ENGINEER'S SUPPLEMENTAL INSTRUCTIONS NO. TWELVE (12)
(Via Posting to FTP Site and Electronic Mail)

RE: Harold D. Thompson Regional Water Reclamation Facility (HDTRWRF)-Phase 1
ENGINEER'S SUPPLEMENTAL INSTRUCTIONS NO. TWELVE (ESI-012)

The ESI-012 addresses modifications to the project drawings relative to the Pumping and Disinfection Building which were issued September 16, 2011 for preparation of the CMO covering the foundation scope of work. The modifications described in this ESI appear on the Pikes Peak Regional Building Department (PPRBD) foundation only permit submittal drawings. Please distribute this ESI to any and all suppliers and subcontractors so the items described herein may be accounted for in the foundation CMO prepared for the Pumping and Disinfection Building. The following is a list of drawing modifications arranged by sheet number.

STRUCTURAL FLOOR PLAN

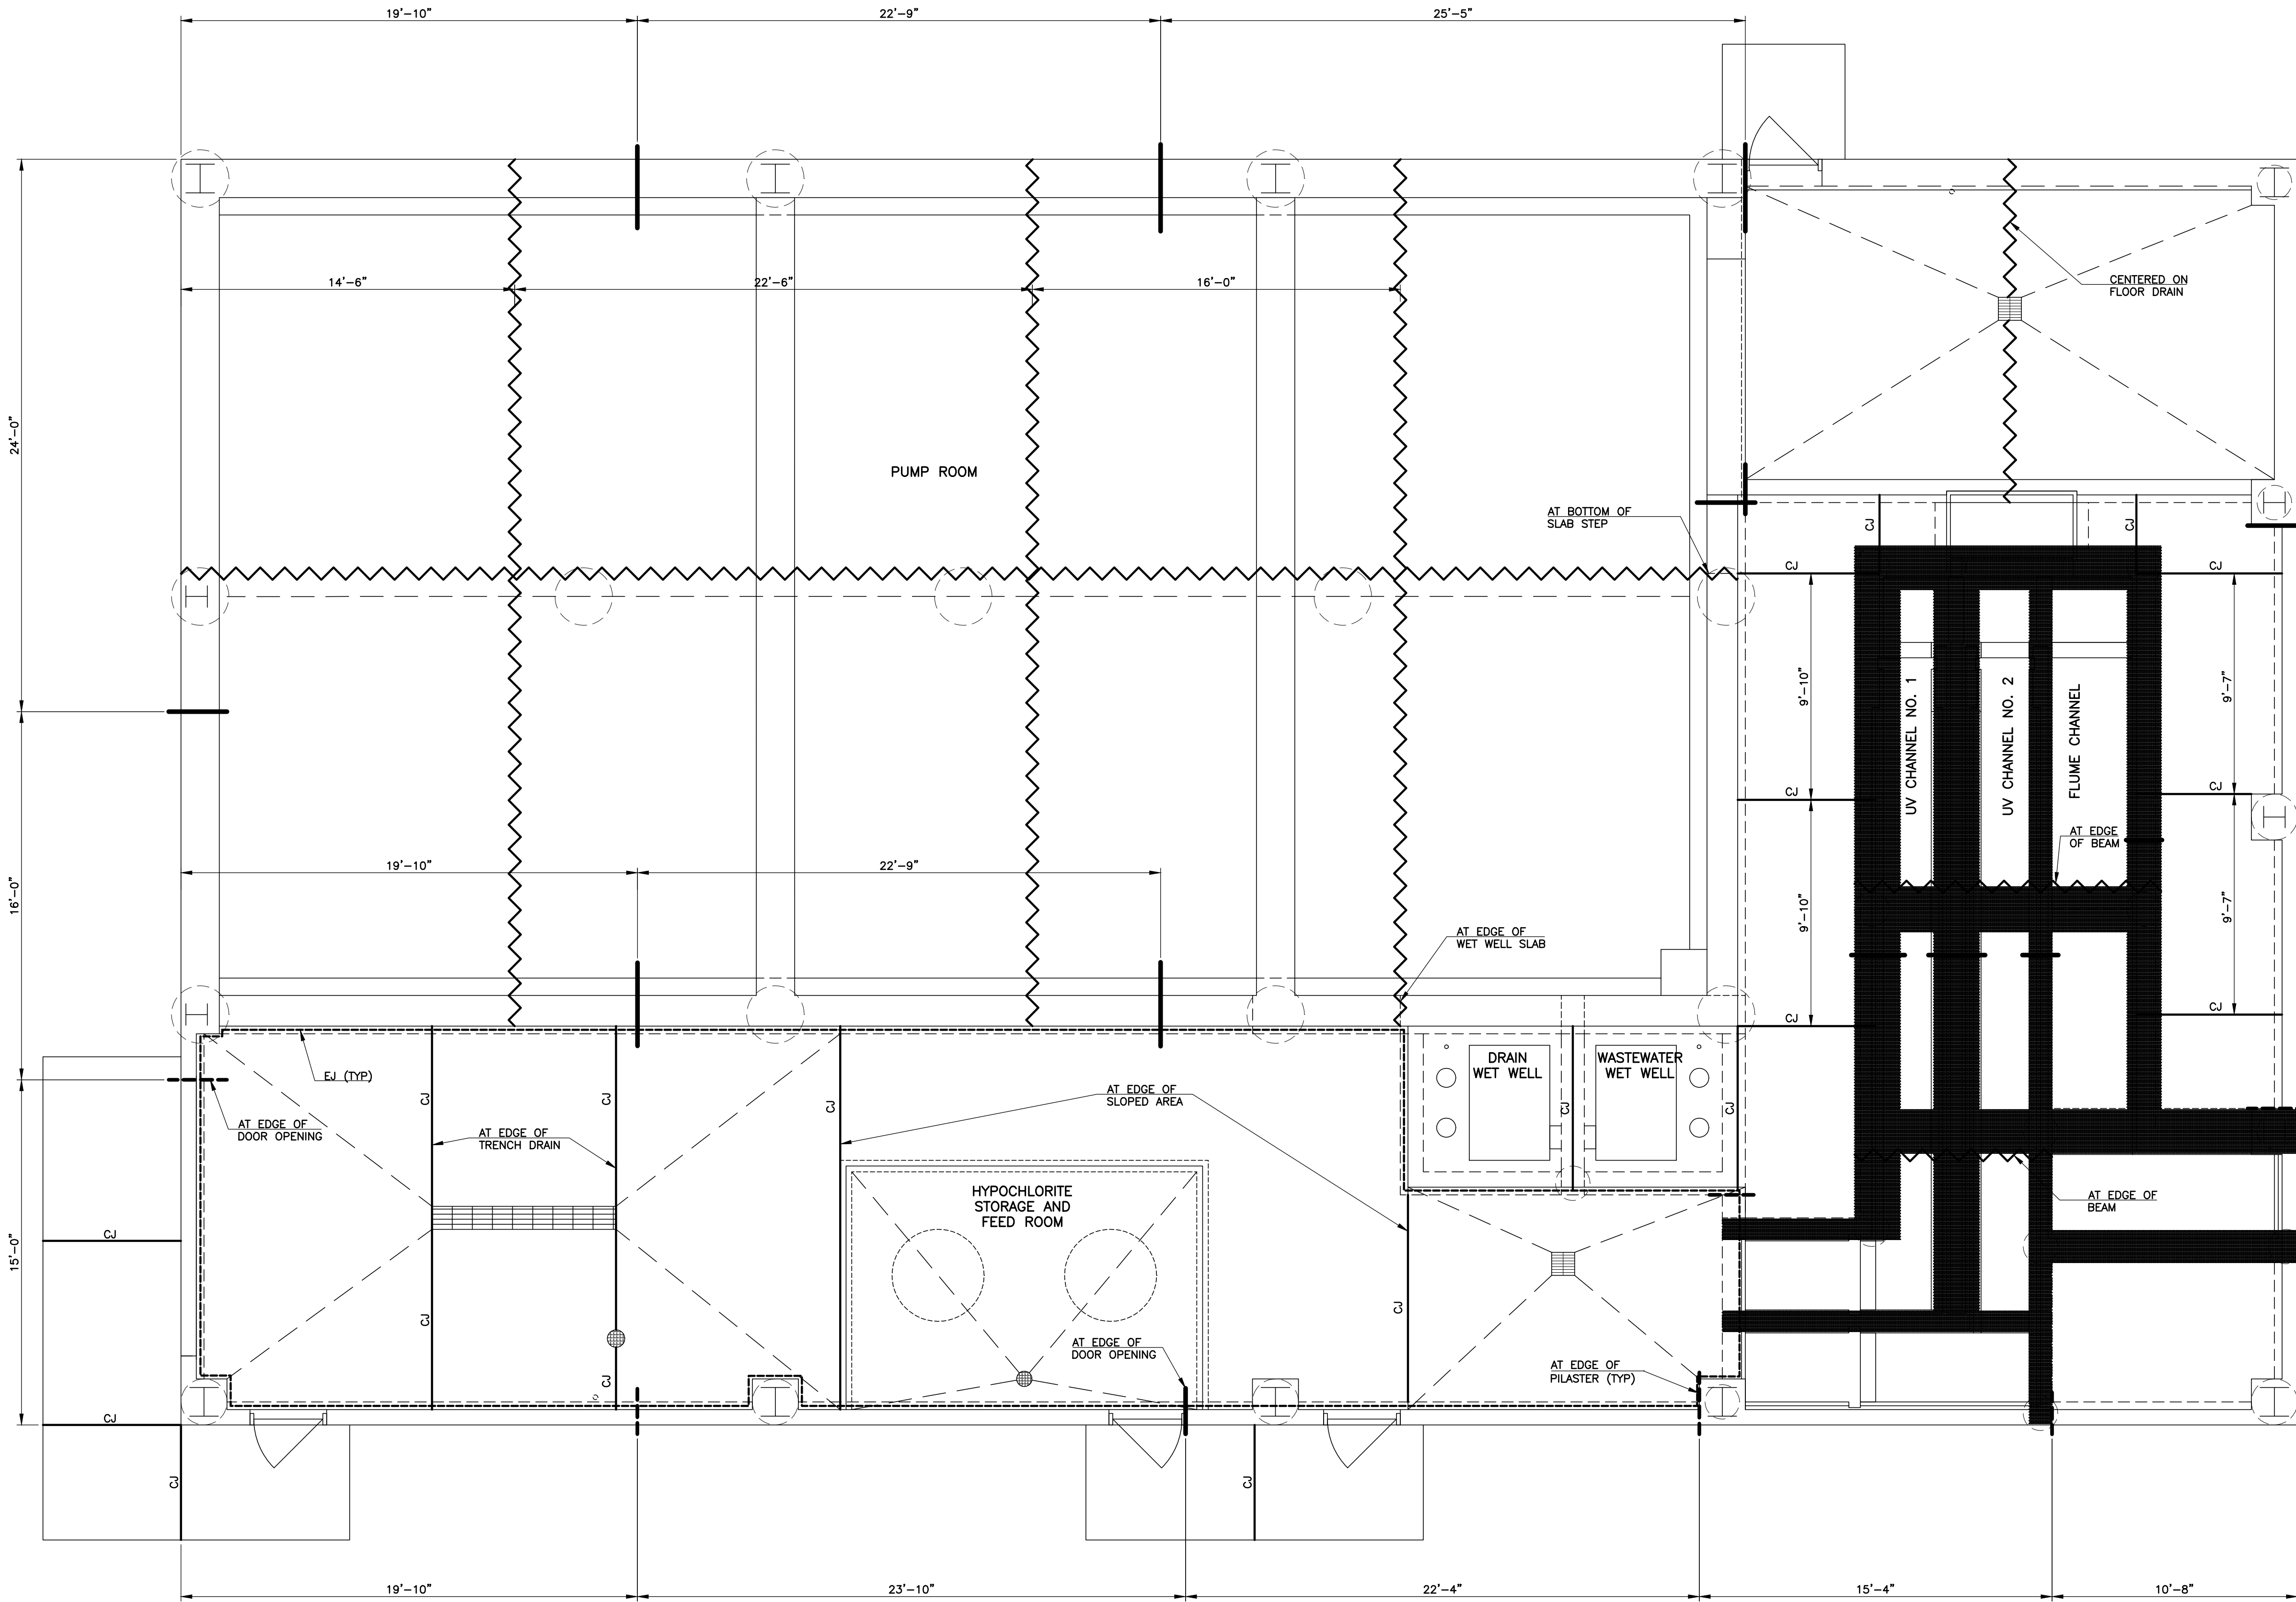
- Sheet PD-5
 - Revised details relative to the Hypochlorite Storage and Feed Room as previously described for Sheet PD-4, along with dimensions relative to the placement of the containment curb and water stop

- Revise the trench drain clean out location as previously described for Sheet PD-4
 - Revise the Wastewater Wetwell top of slab elevation to 5387.00
 - Added Note 6 to reference the Jointing Plan for wall and slab joint requirements

1 PUMPING AND DISINFECTION BUILDING JOINTING PLAN
PD-5A SCALE: 1" = 4'

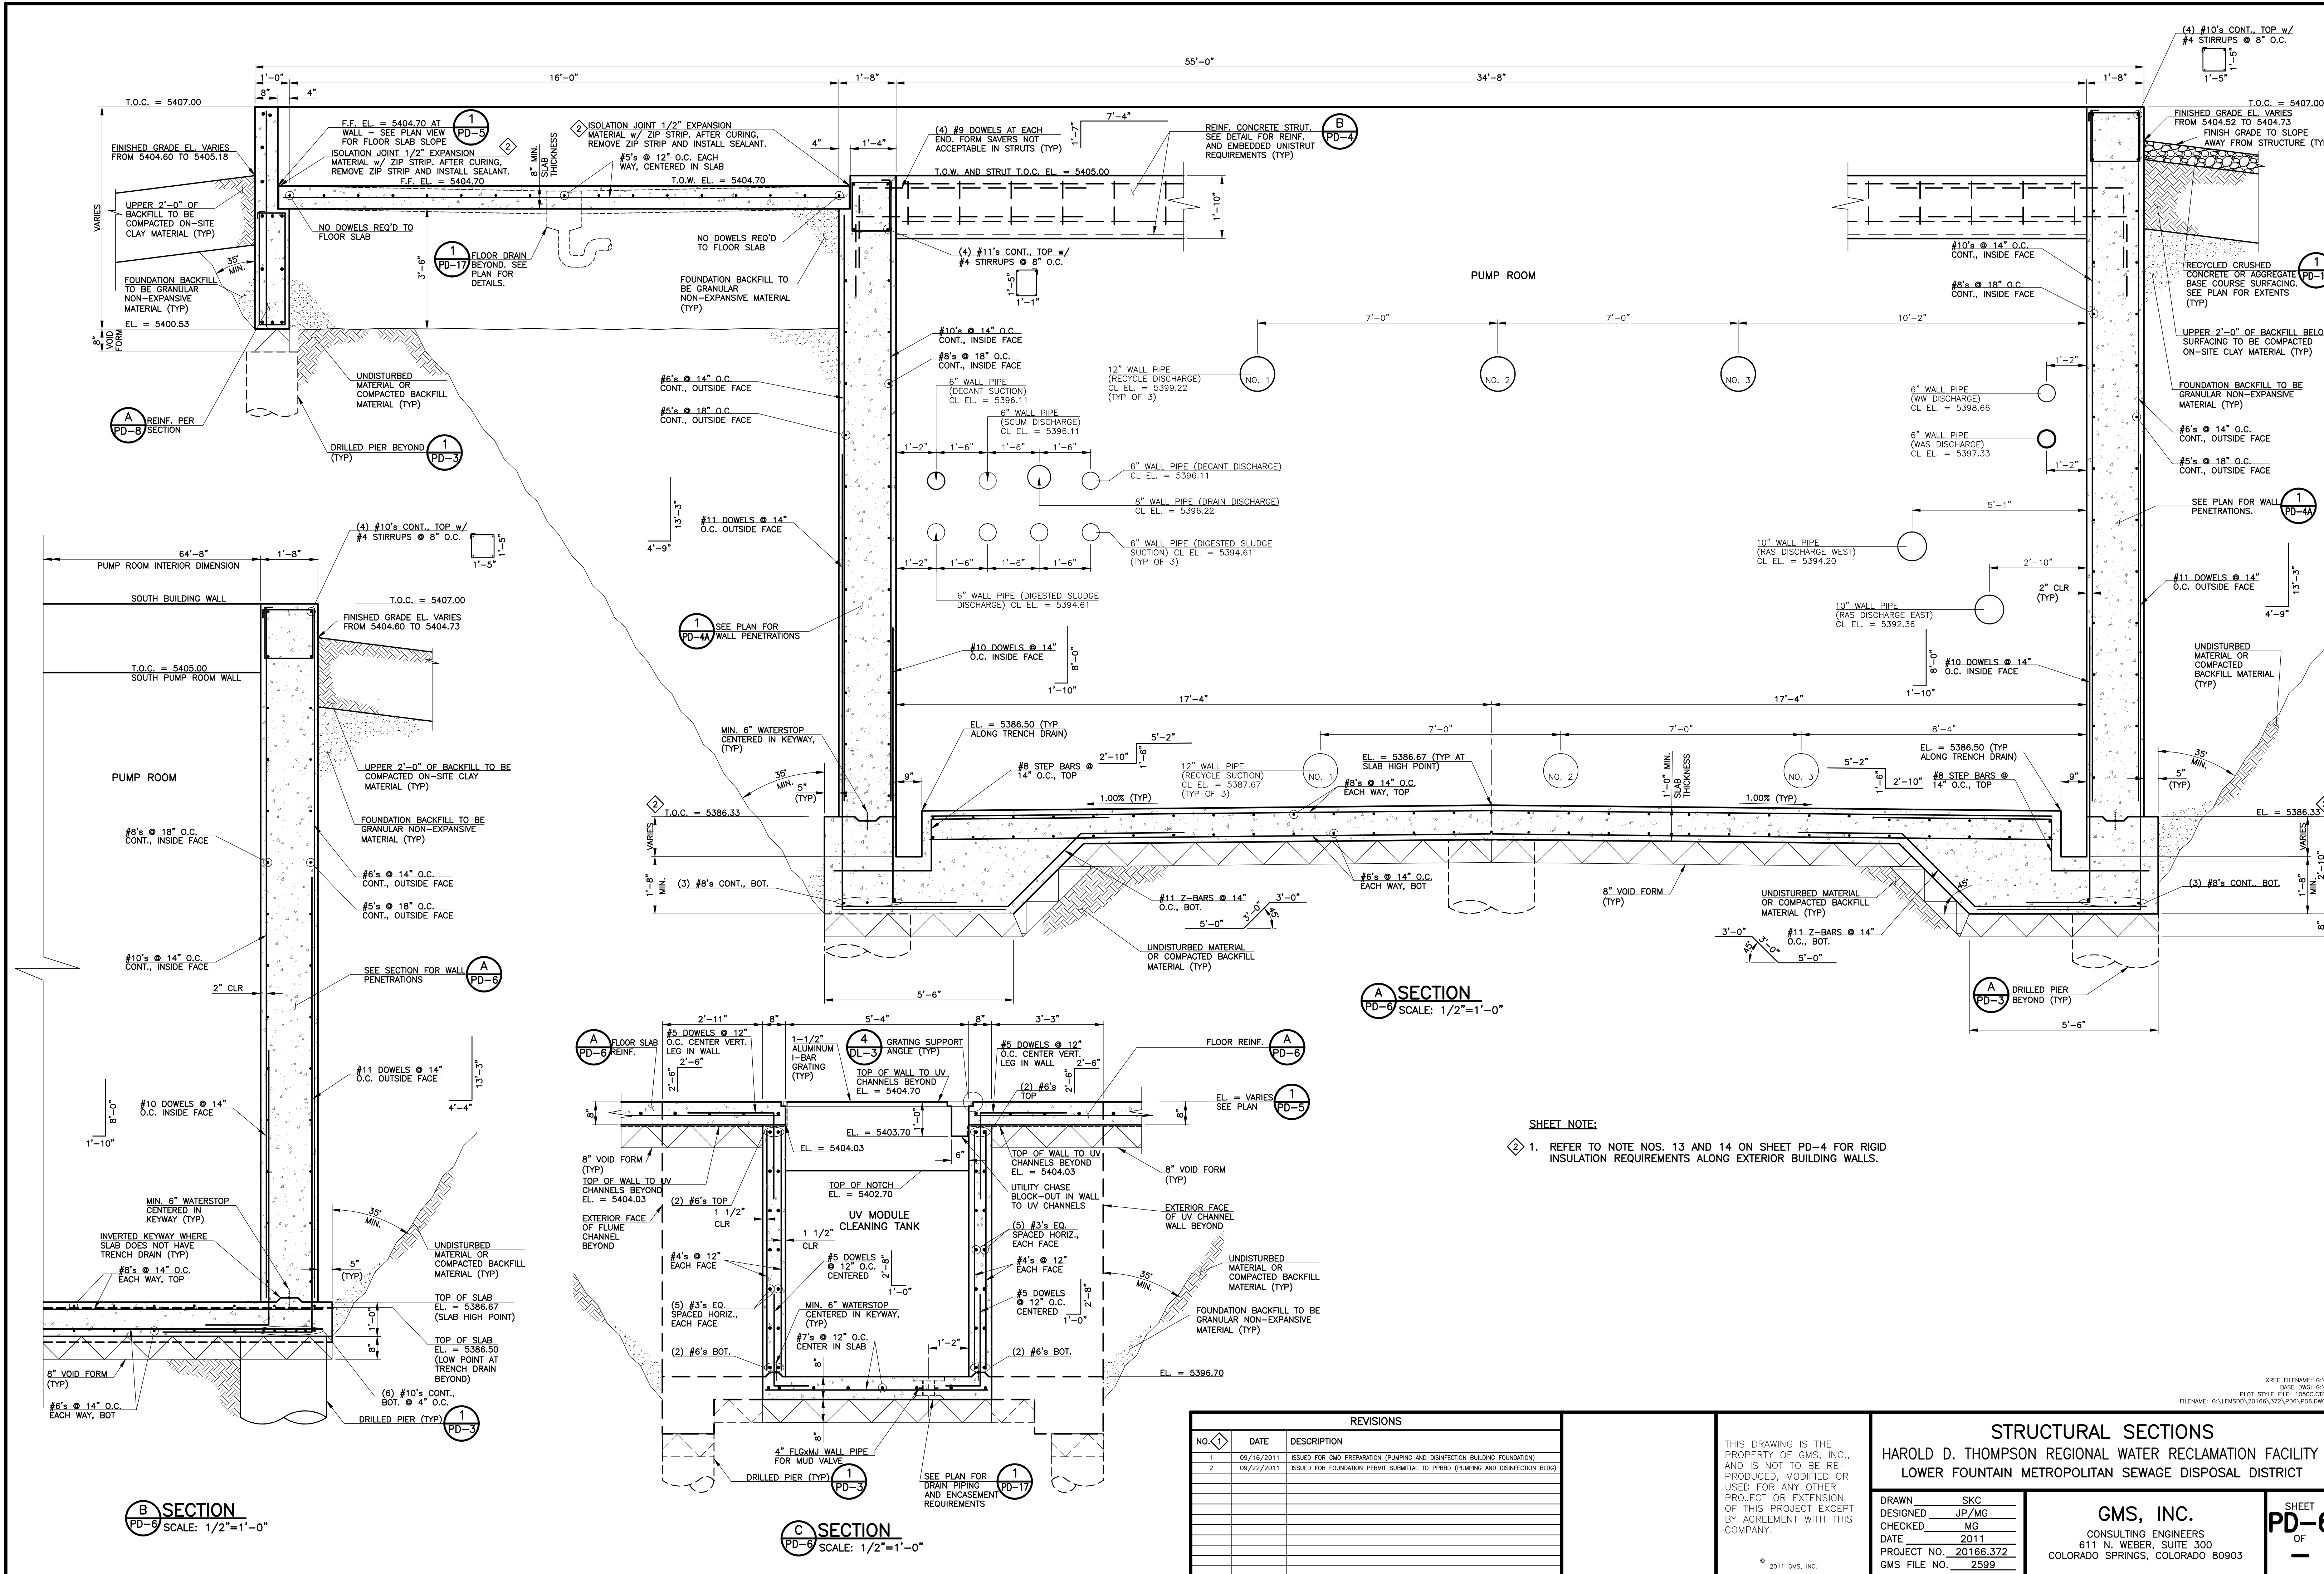
- Sheet PD-5A
 - New drawing titled Jointing Plan to indicate the requirements for wall and slab joints of the Pumping and Disinfection Building
- Sheet PD-6
